Engineering Services for Storm Projects ADDENDUM #1

Addendum #1 dated December 12th, 2019 is issued to notify the following changes, deletions, additions, corrections and clarifications to the RFQ and other documents comprising the Contract Documents for the above noted City of Lynnwood project.

Project #10 - Construction of Flood Wall.

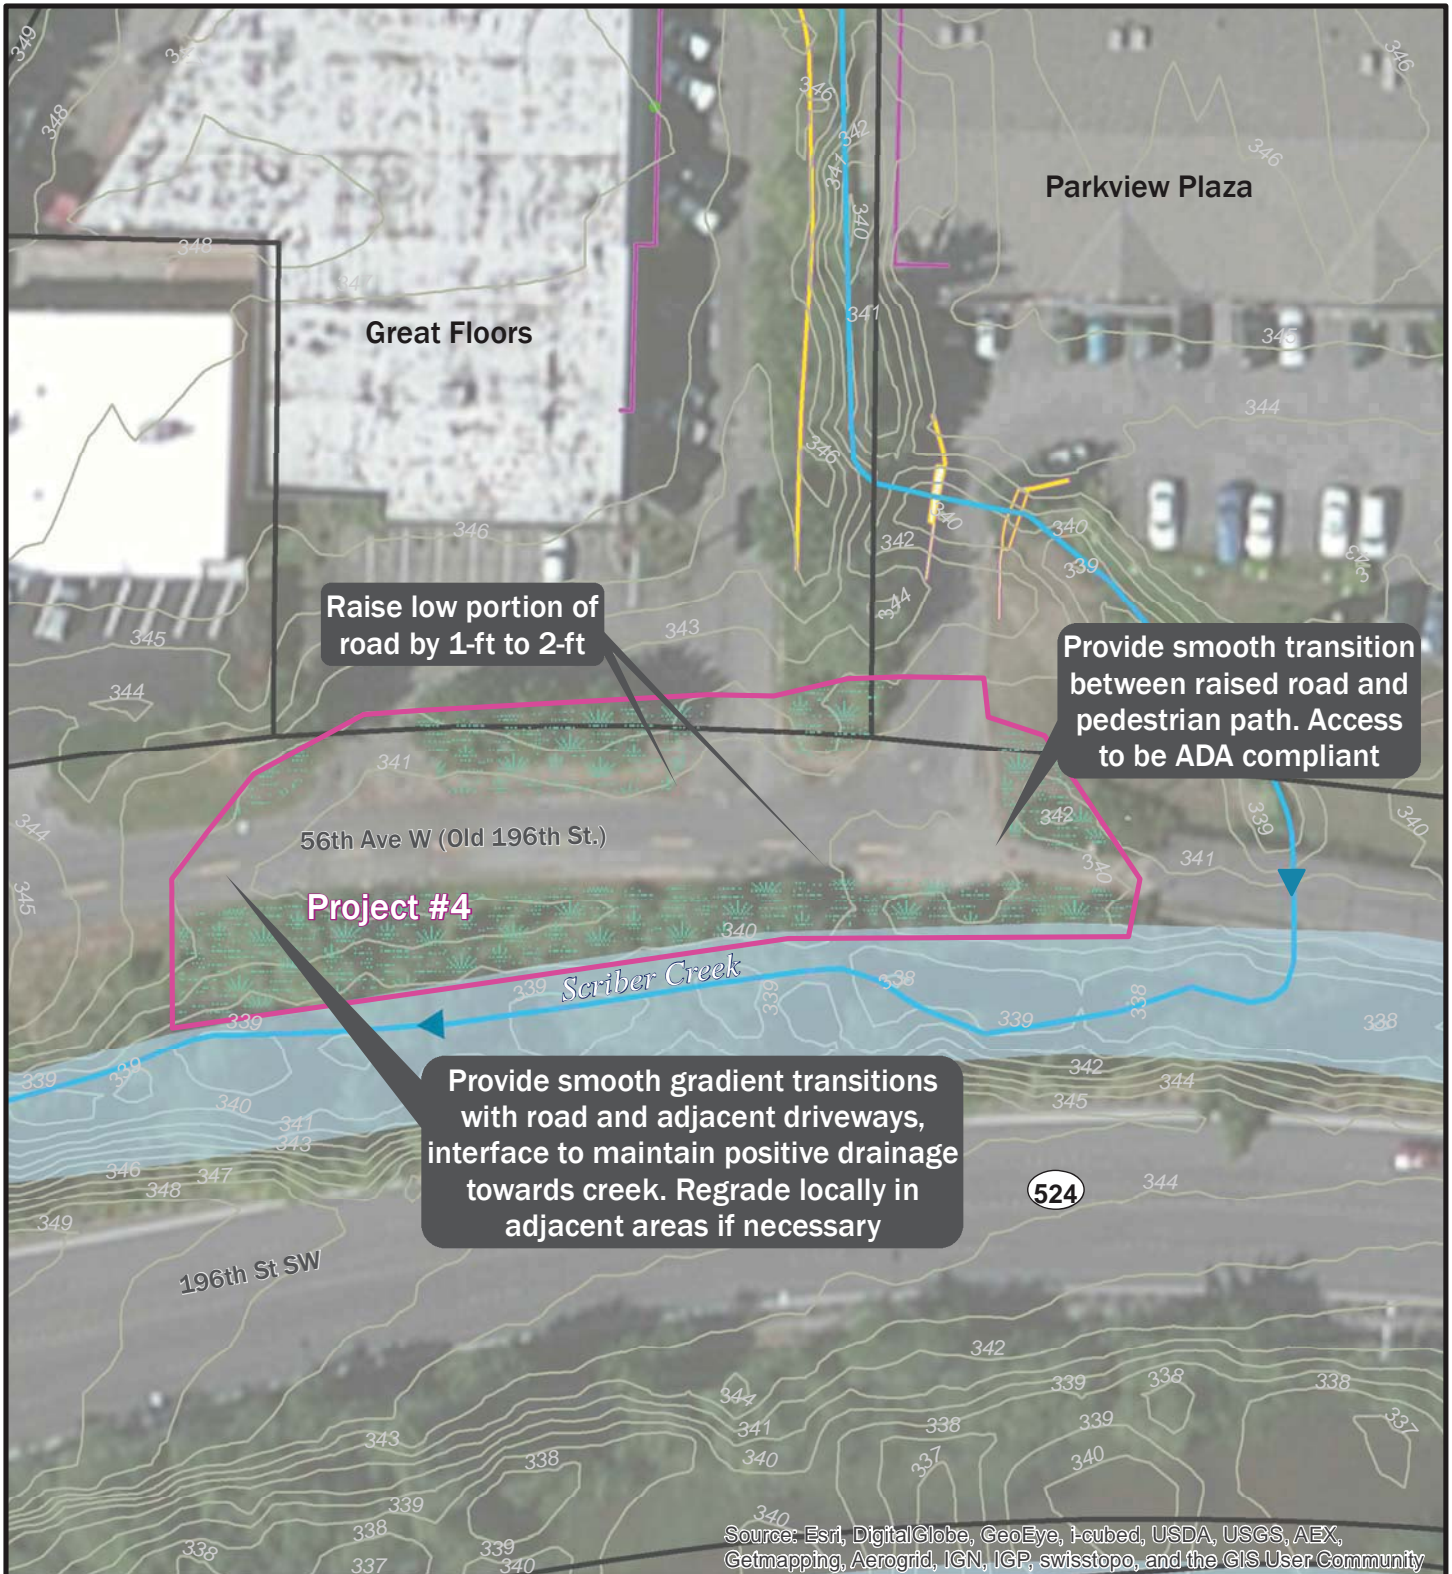
7. Do you have a sketch showing approximate limits of where the 188th St SW wall will be located?

Answer: Three pages of site maps and project boundaries have been attached to this addendum for all three projects.

Figure 3.6
Site Map

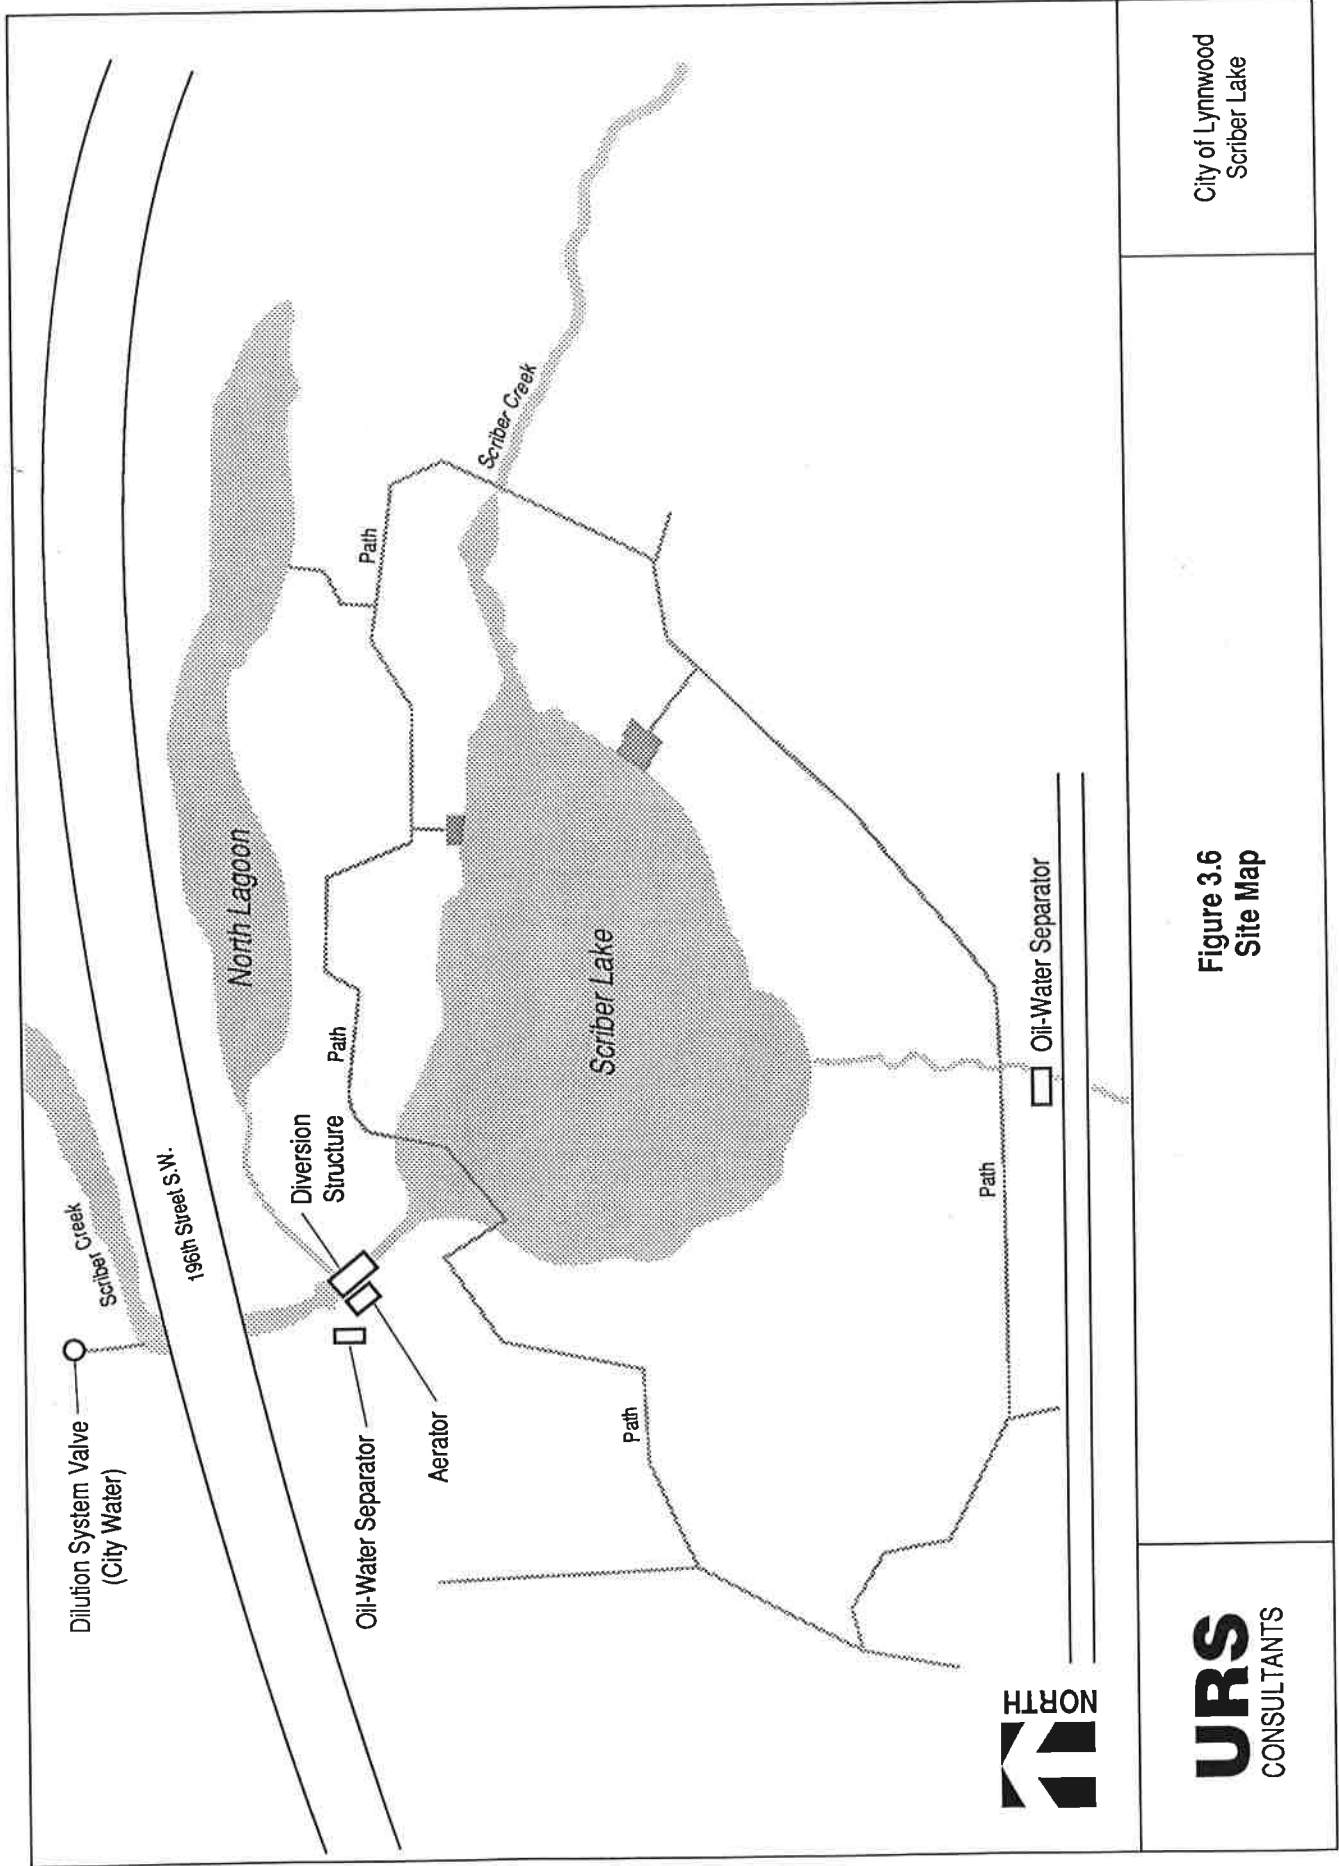
4. Are as-built plans for the pumps and oil/water separator at Scriber Lake available for review?

Answer: URS Consultants prepared a report for scriber lake restoration project in March 1992. The relevant pages of the report have been attached to this addendum. The electronic version of the report is not currently available.
